CITY OF PORTLAND, OREGON BUREAU OF PLANNING

MEMORANDUM

To: Interested Parties
From: Barry Manning, Senior Planner
Date: May 26, 2004
Re: Summary of St. Johns/Lombard Plan Amendments

Vanderbilt Street: Amendment to Recommended Comprehensive Plan and Zoning Map (shaded area).

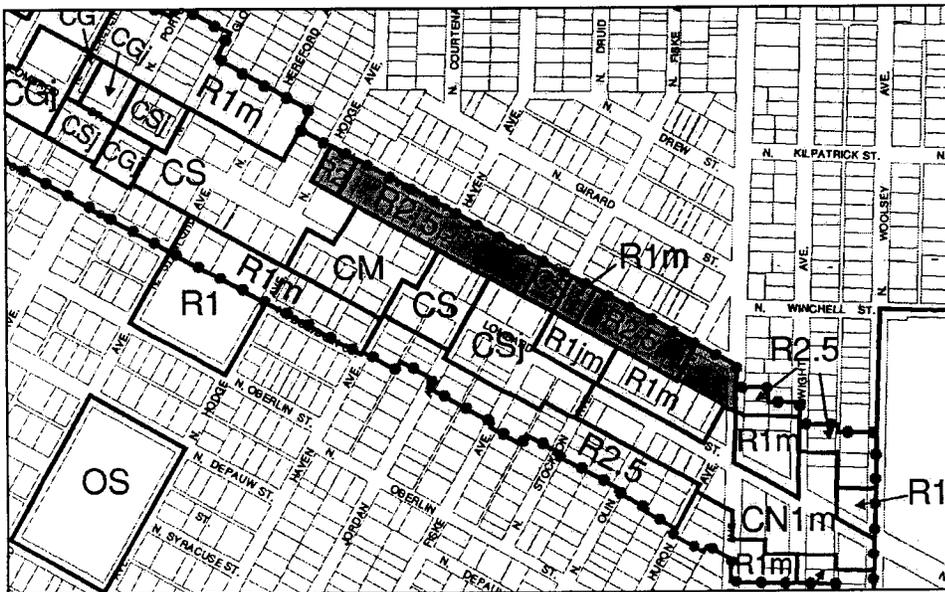
Item 6: Vanderbilt Street: zoning

Rezone selected properties on Vanderbilt Street from R1 to R2.5, as indicated on the map below.
